Office Action Summary

10/731,882

DETAILED ACTION

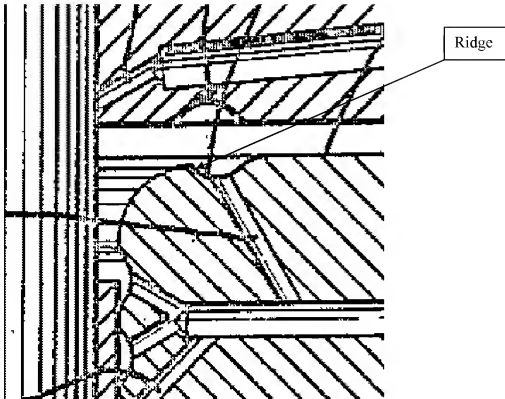
Tsubota discloses placing sheet A between punch 3 and die 7, 11; die hole is in the center of element 7, through which punch 3 passes; delivering lubricant via element 21 as shown in figure 1; actuating the punch as shown in figure 2; the element A in figure 2, which is shown

passing through elements 7 and 11 is considered to be an electrode layer for a flat capacitor; the sheet is aluminum as disclosed in column 4, line 31; aluminum sheets inherently have an aluminum oxide portion due to the sheets exposure to air as evidenced by Frank et al (2,854,074) in column 1, line 27-29; the portions of the aluminum sheet that are exposed to air and have aluminum oxide on them are considered to be distinct portions; the aluminum portion of the sheet is considered to be a distinct aluminum portion; the lubricant is concentrated on the periphery of the die hole where the punch cuts through the aluminum portion as shown in figure 1, and each location about the periphery of the die hole is considered to be a specific predetermined location on the periphery of the die hole.

Tsubota does not teach the die hole having a lubricant dam having a ridge extending around a periphery of an open upper end of the die hole and a reservoir behind the ridge; and delivering a lubricant to the lubricant dam by an opening on the dam.
